# MONITORING YEAR 6 ANNUAL REPORT

## MOORES FORK STREAM MITIGATION PROJECT

RE: Moores Fork Stream Mitigation Project  
Yadkin River Basin – CU# 03040101  
Surry County, North Carolina  
NCEEP Project # 94709  
Contract No. 6500

Wildlands Engineering, Inc. (Wildlands) has reviewed the Division of Mitigation Services (DMS) comments from the Draft Monitoring Year 6 report for the Moores Fork Stream Mitigation Project. The following Wildlands responses to DMS's report comments are noted in italics lettering.

Figure 3.0 Current Condition Plan View (Key)  
 Moores Fork Stream Mitigation Project  
 DMS Project No. 94709  
 Monitoring Year 6 - 2021  
 Surry County, NC

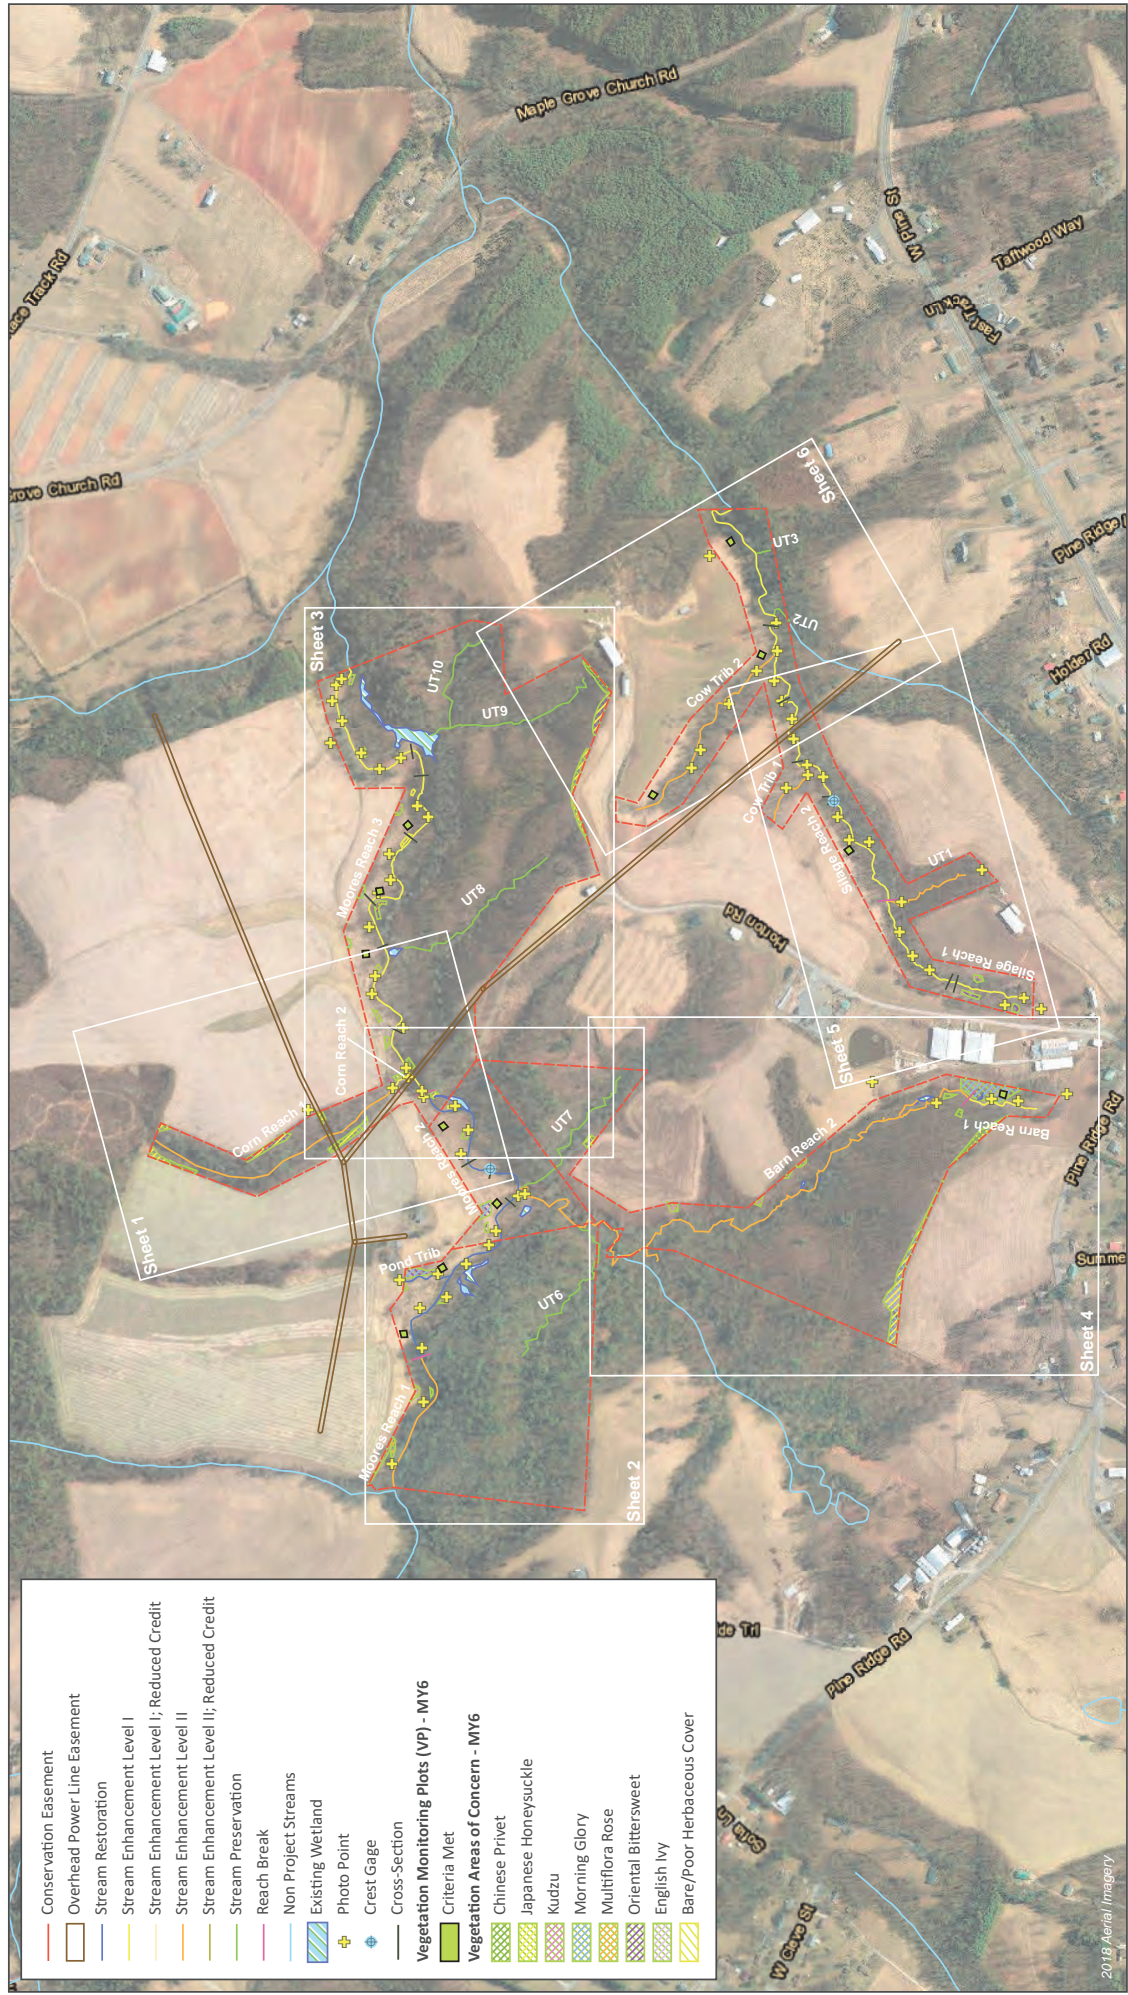
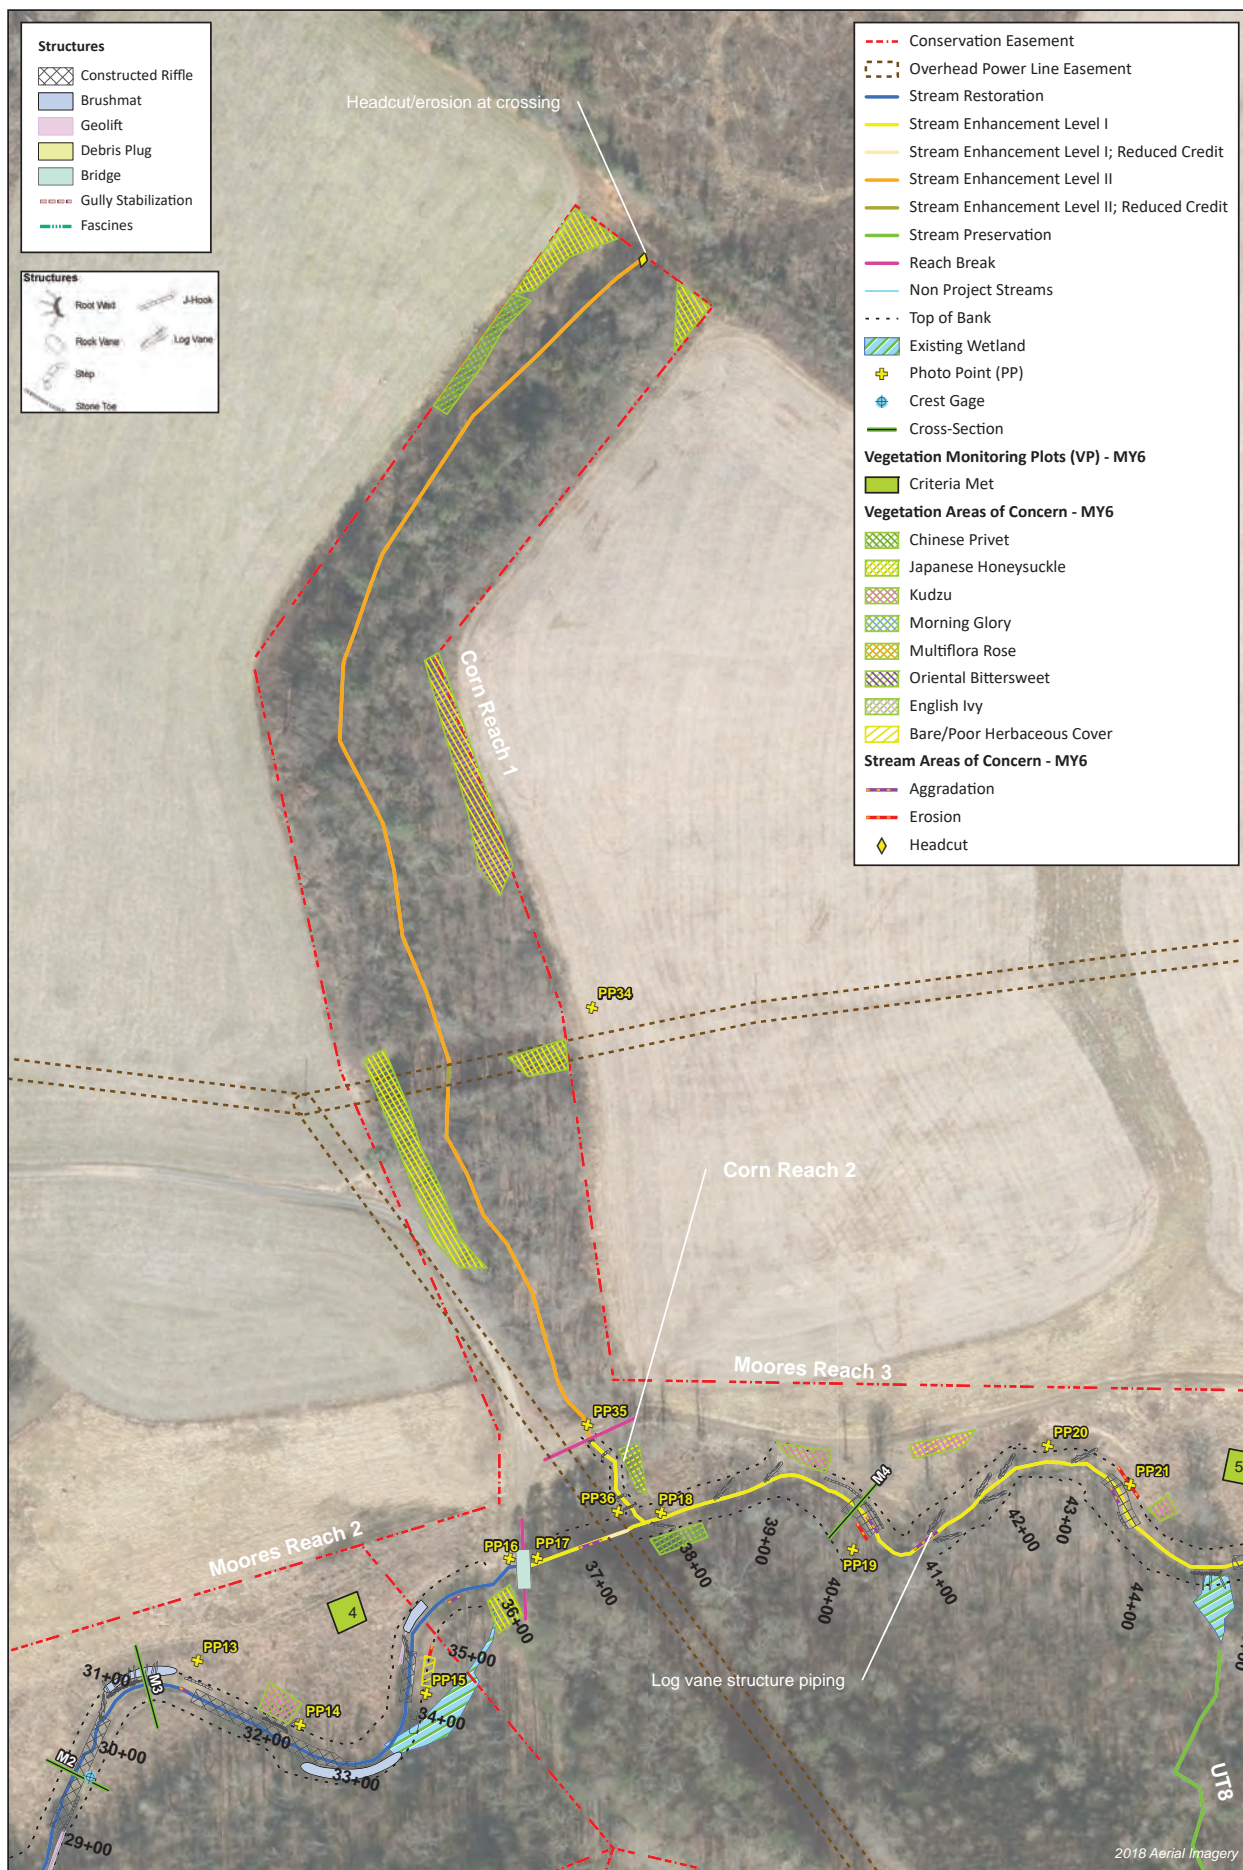
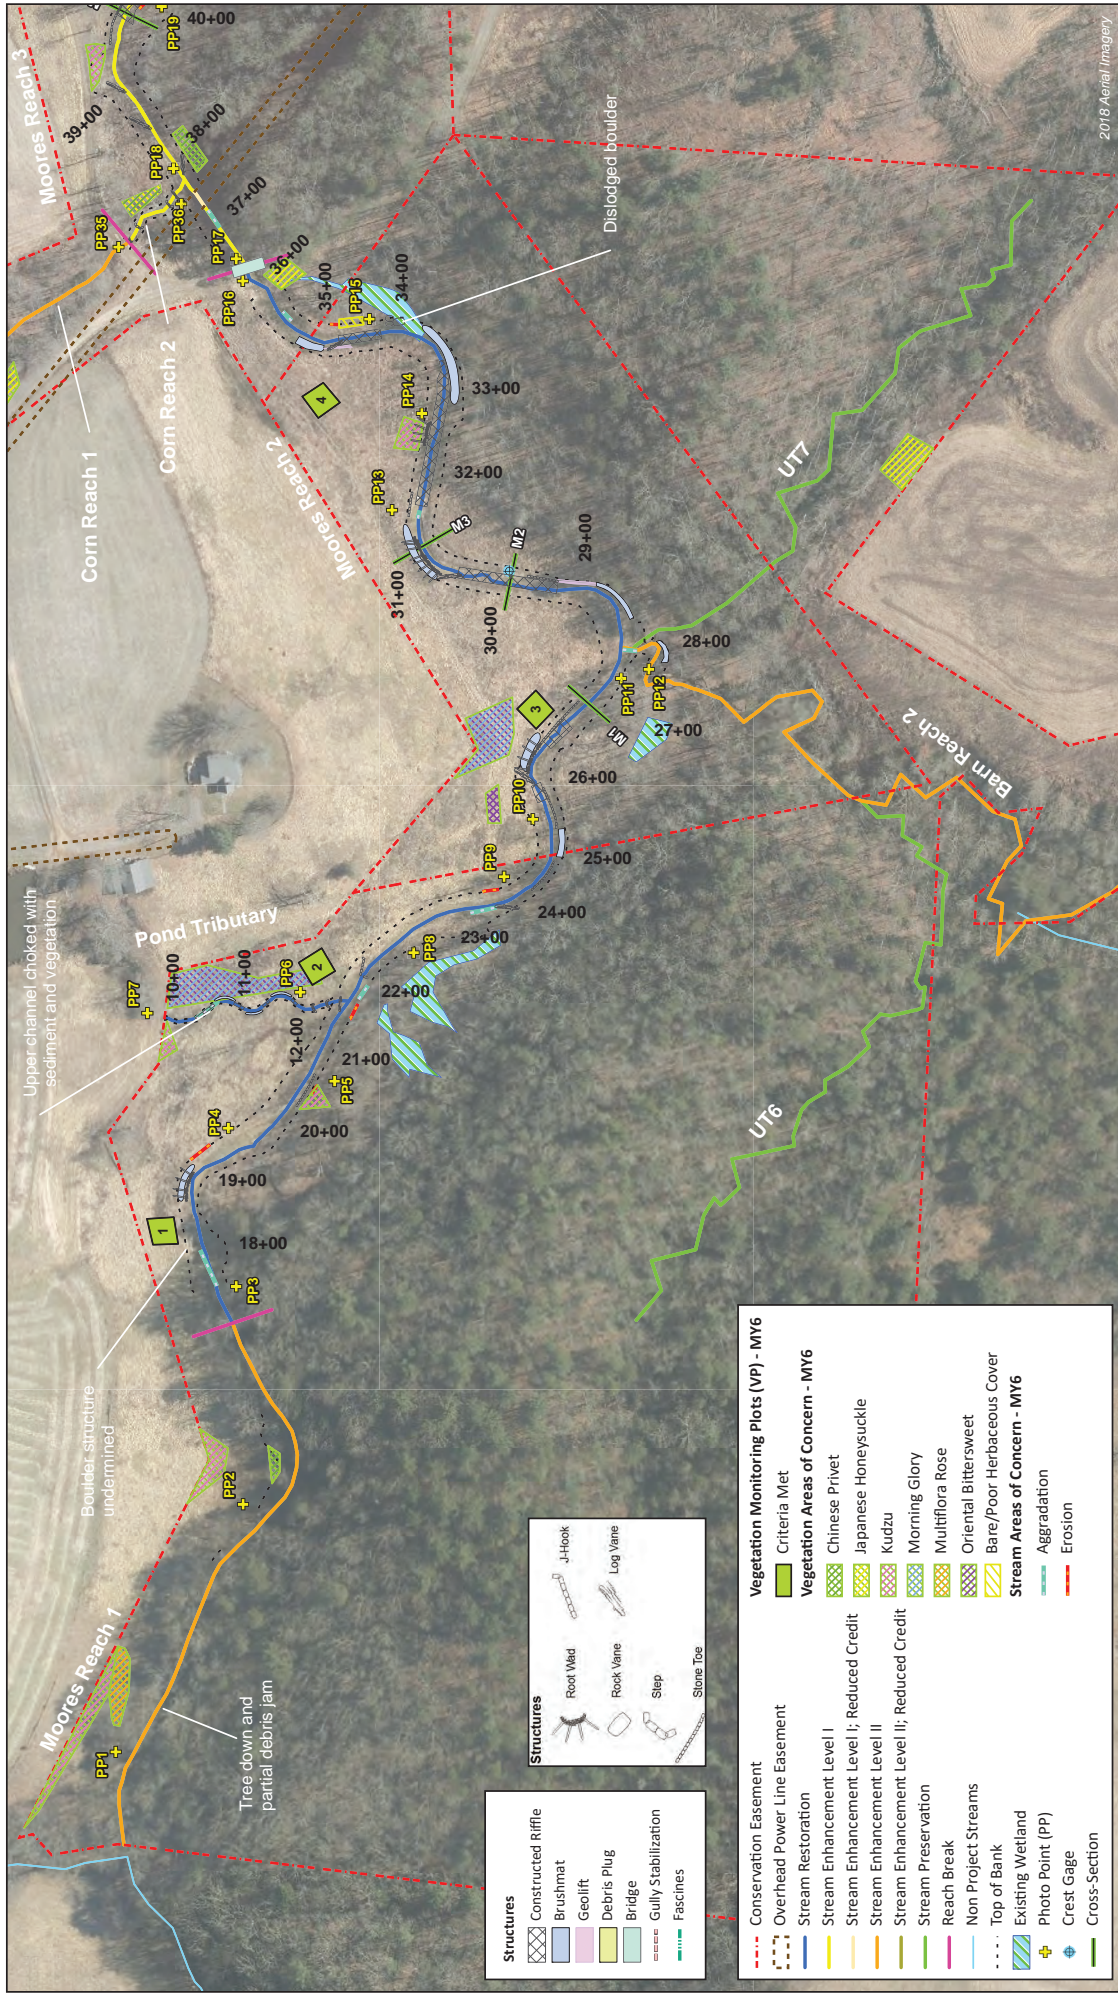
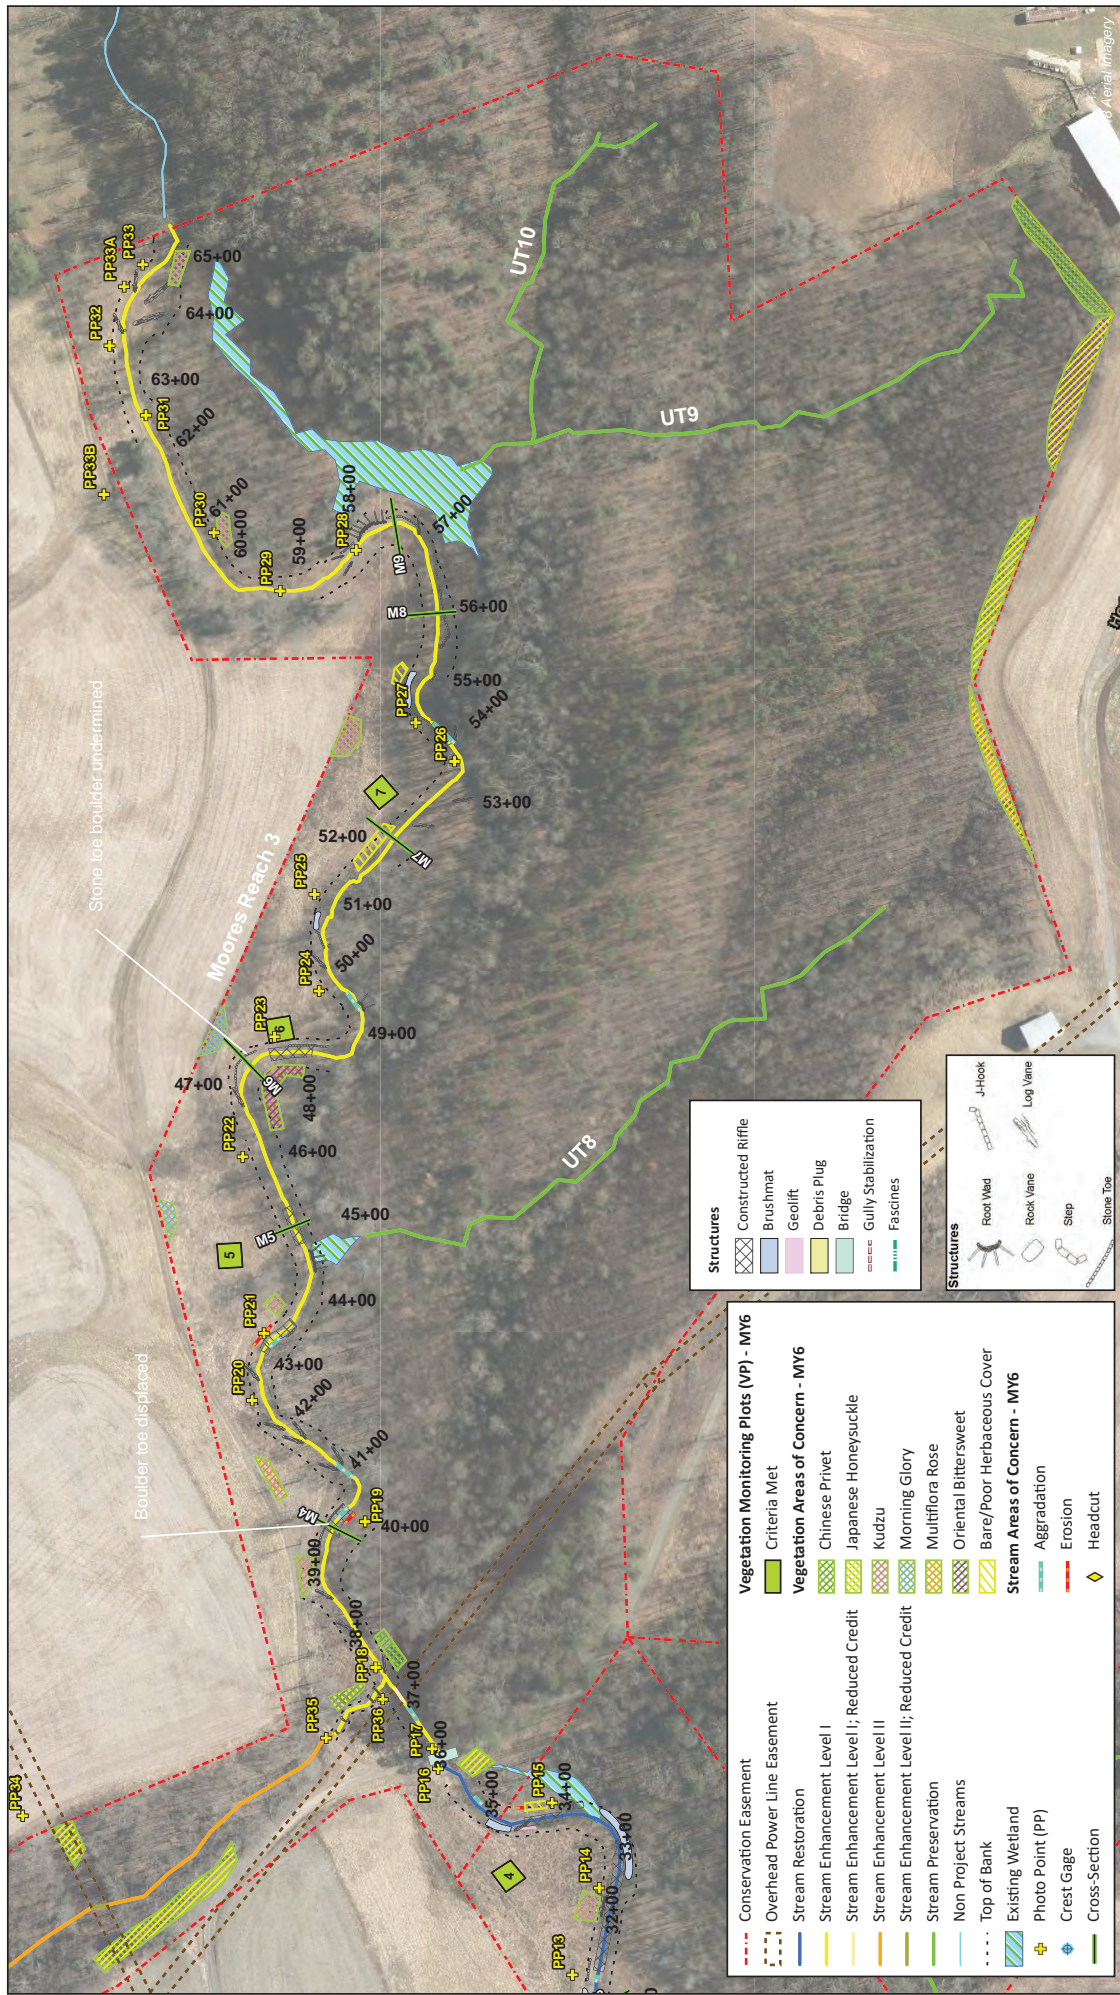
**DMS comment: CCPV: Thanks for providing updated invasive species polygons. Please continue to update as treatment occurs and populations are reduced. This map is a useful tool for the contractor treating the site. DMS will continue treating invasives until the project is closed.**

*Wildlands response: You're welcome. Wildlands will continue to update the CCPV figures as treatment of invasive species occurs, and populations are reduced.*
